URGENT MEDICAL DEVICE CORRECTION (NOTIFICATION)
Update to Instructions for Use

Abiomed, Inc (“Abiomed”) has initiated a device correction (notification) to inform you of updates that are being added to the Instructions for Use (IFU) for all Impella products listed below. This is not a product removal.

Example of a “Placement Signal Not Reliable” alarm that may occur:

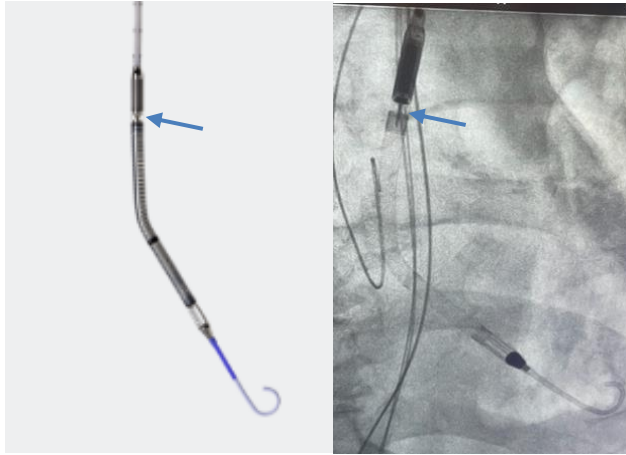
Abiomed has determined that there is a risk of optical sensor damage in Impella products as listed above when used concurrently and in close proximity with Shockwave Coronary IVL Catheter. Placement Signal Not Reliable alarm may occur and subsequently disable pump position monitoring. Loss of the placement signal does not impact Impella hemodynamic support.

If optical sensor failure occurs, monitor patient hemodynamics and confirm Impella positioning with imaging. The pump will still operate without placement or suction monitoring or alarm notifications.

Reference for location of optical sensor in Impella devices

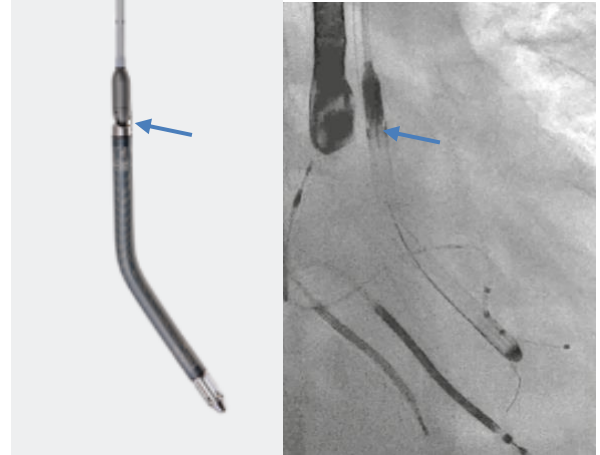
Abiomed recommends the user to maintain adequate distance (> 20 mm) between the Shockwave Coronary IVL Catheter and Impella optical sensor and include optimal positioning of the Impella catheter with the radiopaque marker band located at the aortic valve annulus.

- Use with Shockwave Coronary Intravascular Lithotripsy (IVL) Catheter at a distance of less than 20 mm between the optical sensor and IVL device may interfere with or damage the Impella optical sensor. Prior to IVL therapy pulsing, physicians should assess and verify this distance. If the placement signal is not displayed, monitor patient hemodynamics and confirm Impella position with imaging and motor current pulsatility. Loss of the placement signal does not impact Impella hemodynamic support.

- Shockwave Coronary Intravascular Lithotripsy (IVL) Catheter
The pressure waves emitted from a Shockwave Coronary Intravascular Lithotripsy (IVL) Catheter may interfere with or damage the optical pressure sensor when the Shockwave Coronary IVL device is less than 20 mm from the Impella optical sensor. Best practices to maintain adequate distance between the Shockwave Coronary IVL device and Impella optical sensor include optimal positioning of the Impella catheter with the radiopaque marker band located at the aortic valve annulus. Prior to pulsing, physician users should ensure the shortest distance from the Shockwave Coronary IVL device to the Impella optical sensor is ≥ 20 mm.
